**RIDGECREST SOLAR POWER PROJECT (09-AFC-9)
DATA ADEQUACY SUPPLEMENT**

Technical Area: Transmission System Design

Response Date: October 26, 2009

Following are additional information and/or clarifications in response to the specific issues raised in the CEC staff Data Adequacy review. For each specific area where the questions were raised by CEC staff, the applicable section of the CEC Siting Regulations is identified, followed by the "Information Required to Make AFC Conform with Regulations," followed by the supplemental/clarifying information.

Figure 2-12
Transmission Line
Facilities and Routes

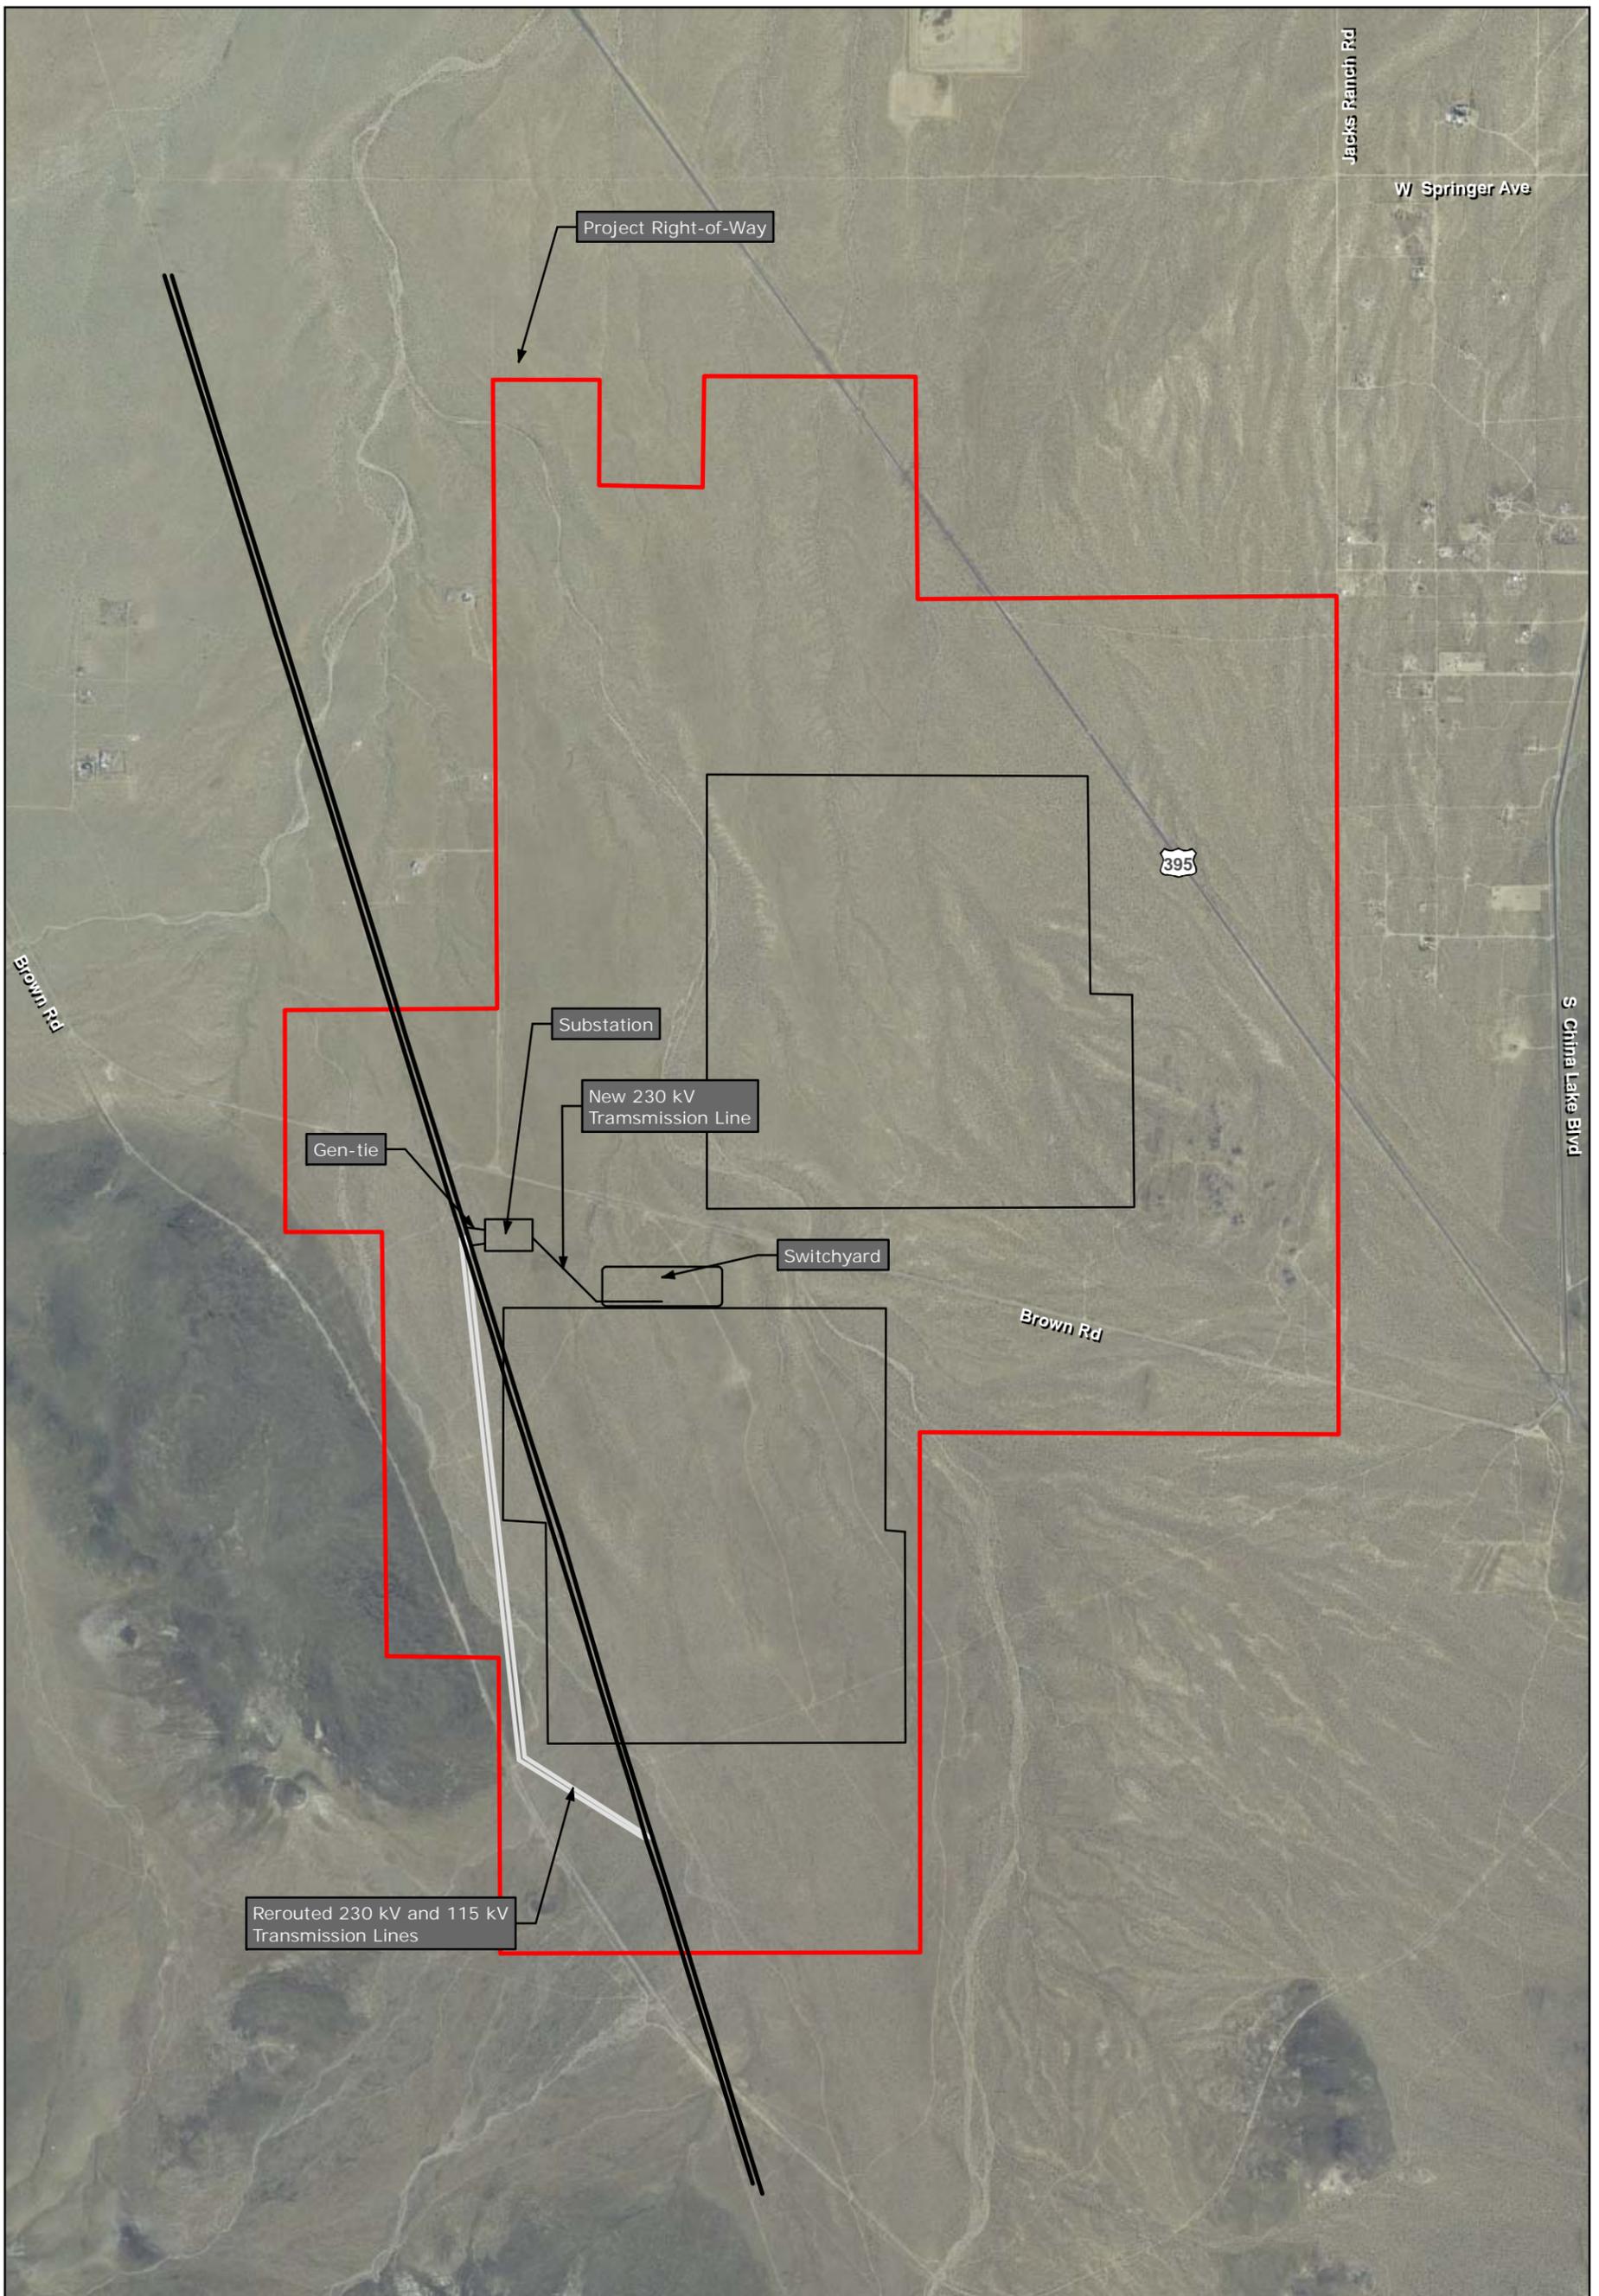
Provide a physical layout drawing showing distinctly the route of the proposed 0.5-mile 230 kV overhead generator tie line in and out of the plant site between the proposed Ridgecrest Solar Power Project (RSPP) 230 kV switchyard and proposed new SCE 230 kV substation including Right of Way (ROW) widths. Describe whether the ROW would be through private and/or public lands. Also include in the diagram the existing and relocated routes of 1.4-mile transmission lines in the project site.

Please refer to the new Figure 2-12 depicting the route of the proposed 0.5 mile 230 kV overhead transmission line connecting the power block 230 kV switchyard to the new SCE's Millennium 230 kV substation (as a note for clarification, the substation is referred to as the switchyard in the Ridgecrest AFC, but in this and in subsequent responses, it will be referred to as the substation). The figure also depicts the generator tie line in and out of the Millennium substation to the existing SCE 230 kV transmission line, located to the west. The proposed transmission line route between the power block and the new substation, the proposed transmission line route between the new substation and the existing transmission lines, and the relocated existing 115 kV and 230 kV lines are all entirely within the proposed Project ROW, all within federal lands managed by the BLM. No private lands are affected.

FIGURE 2-9

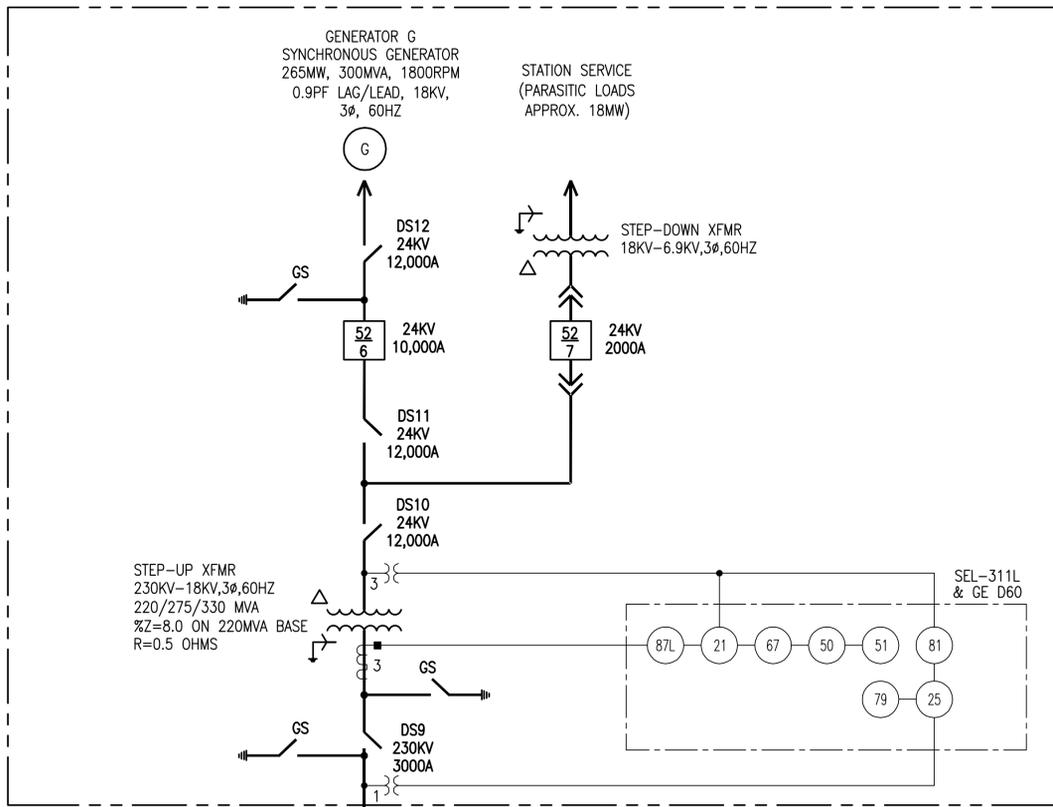
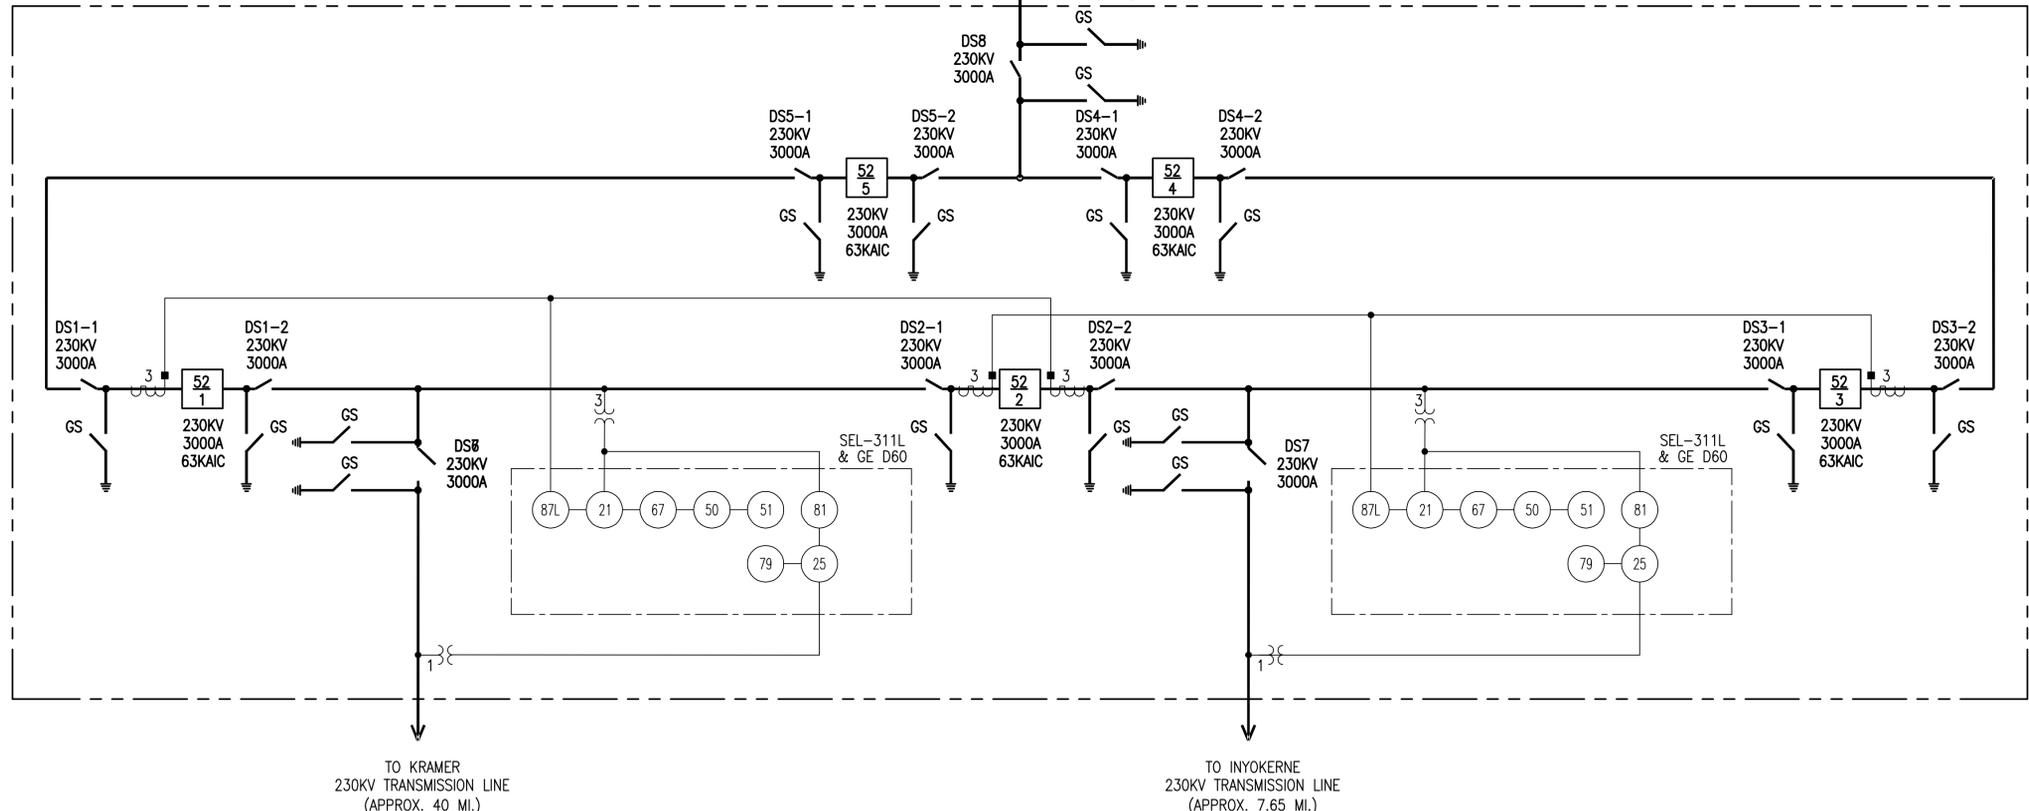
- (c) Provide a one-line electrical diagram (or resubmit Figure 2.9 with missing elements) showing the proposed new SCE 230 kV substation with the proposed 230 kV generator tie line interconnection facilities for buses, breakers and disconnect switches and their respective sizes and/or ratings.
- (d) Provide a physical layout drawing of the proposed new SCE substation showing all major equipment and transmission outlets.

- (b) The current Figure 2-8 in the AFC illustrates the elements of the RSPP power block switchyard. The revised Figure 2-9, provided at the end of this section, contains the one-line drawing for the new SCE Millennium substation, including all CEC requested items.

- (c) Please refer to the revised Figure 2-9 provided at the end of this section. The SCE 230 kV transmission line from the existing Kramer Substation to the existing Inyokern Substation runs on the east side of the power plant. A new 230 kV substation will be constructed at the power plant site. This new substation will bisect this existing 230 kV transmission line creating three new line segments: Kramer to Millennium, Millennium to Inyokern and the Ridgecrest Solar Power Project to Millennium.

FIGURE 2-13

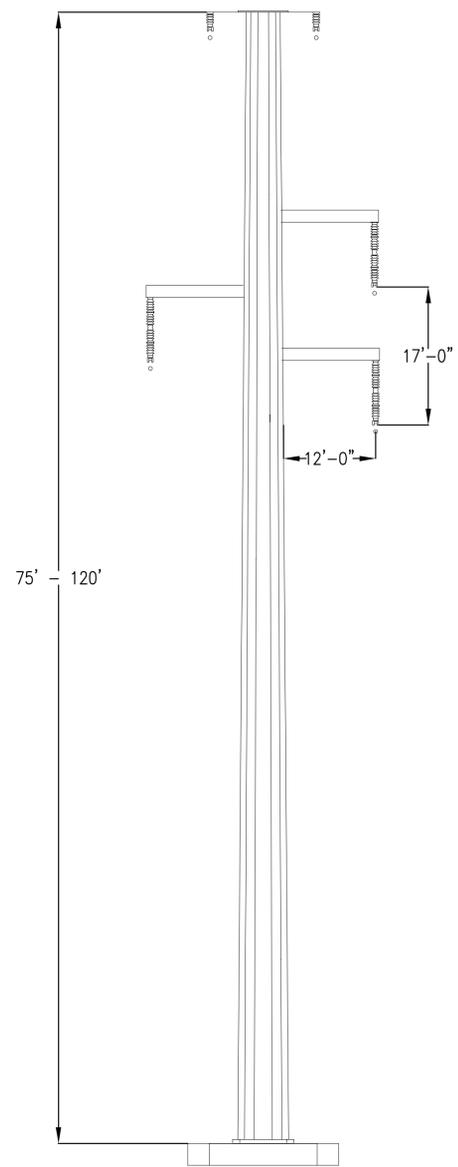
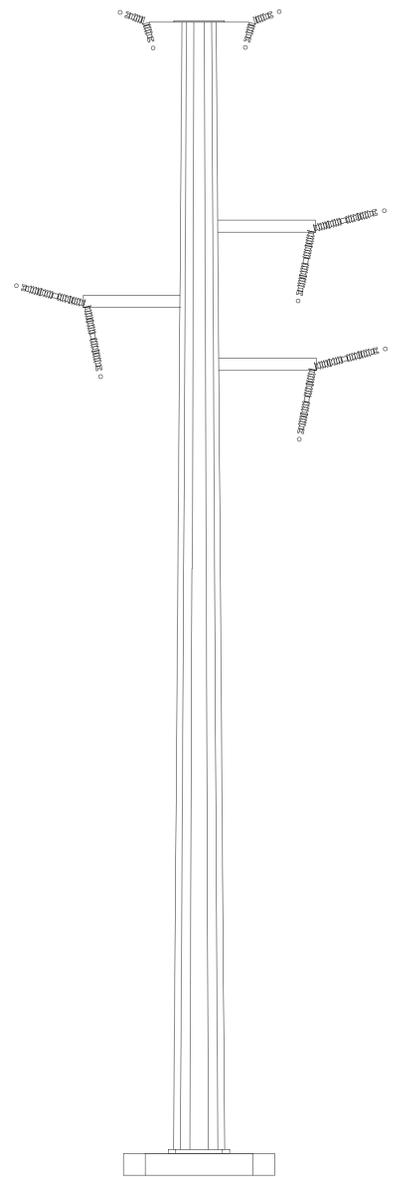
- (a) Submit a Pole design diagram for dead-end structures of the generator overhead 230 kV tie lines showing configuration of insulators and conductors (with sizes, type and ampere rating) with their respective position measurements on the pole.

- (a) Please see Figure 2-13 provided at the end of this section. The new 230 kV circuit line from the power block switchyard to the new SCE Millennium substation will be constructed using a steel monopole made of weathered or galvanized steel. The structures will be bolted or slip-fit design. The structures will be 75 to 120 feet tall, with the phases arranged in a delta configuration. The structures for typical tangent and dead-end applications are shown on Figure 2-13. The base of the pole at ground will be 48 inches for a tangent structure, and slightly larger for dead-end structures depending on span and height of the pole.

The conductors will be single-bundled aluminum conductors, steel-reinforced ("ACSR") 715.5 KCMIL ("Redwing" type 1.081 inches in diameter) on a typical phase spacing of 17 feet and structure-to-conductor distance of 12 feet. Located at the top of the transmission structure will be a lightning OPGW shield wire.

To provide dual communication paths from power block switchyard to the new Millennium substation, a fiber optic line will be embedded in the overhead shield wires and a microwave tower and dish will be installed.

The minimum mid-span line-to-ground clearance will be calculated at an ambient temperature of 130 degrees Fahrenheit under maximum load conditions and typically will be 31 feet. All dimensions will comply with applicable CPUC General Order 95 rules.
